UNITED STATES PATENT AND TRADEMARK OFFICE

10/591,536

Office Action Summary	Application No. 10/591,536	Applicant(s) LENOIR, PATRICK	
	Examiner CHUKA C. NDUBIZU	Art Unit 3743

DETAILED ACTION

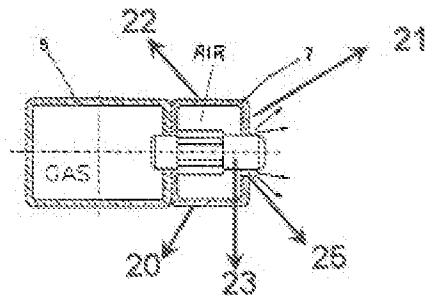
With regard to claims 37, 46 and 57 Aldo discloses a gas burner comprising an air tube 7 comprising opposing first 21 and second (opposite 21) wall regions connected

by longitudinal wall regions 20 and 22 such that an inside space is enclosed by the first, second, and longitudinal wall regions (see fig below); an aperture (on the wall opposite 21) for providing gas inwards to the air tube, wherein the air tube comprises a first aperture 25 at the first wall region for receiving the back tube 23 of the gas burner such that the back tube extends through the first aperture 25 from outside the first wall region into the inside space (see below).

With regard to claims 38 and 58 Aldo also discloses wherein the aperture of the gas tube (through wall opposite 21) and the first aperture 25 of the air tube are substantially aligned (23 is straight, see fig above).

With regard to claims 44 and 67 Aldo also discloses wherein the gas tube is located outside and adjacent to the air tube (see fig above), wherein the air tube comprises a second aperture (opposite 25 where the back tube 23 enters the air tube)

Applicant's arguments with respect to claims 37, 46 and 57 have been considered but are moot in view of the new ground(s) of rejection. Aldo discloses a gas burner comprising an air tube 7 comprising opposing first and second wall regions connected by longitudinal wall regions 20 and 22 such that an inside space is enclosed

by the first, second, and longitudinal wall regions (see fig above); wherein the air tube comprises a first aperture 25 at the first wall region for receiving the back tube 23 of the gas burner, such that the back tube 23 extends through the first aperture from outside the first wall region into the inside space (see fig above). Riepe in view of Aldo discloses all the limitations of the claims. One of ordinary skill in the art would modify Riepe by the teaching of Aldo; namely enclosing part the back tube with the air tube such that Riepe's air inlet to the back tube would be open to air in the air tube and such that the back tube extends through the first aperture from outside the first wall region into the inside space. The motivation would be to cool the back tube and at the same time preheat the combustion air and thereby enhance combustion efficiency.
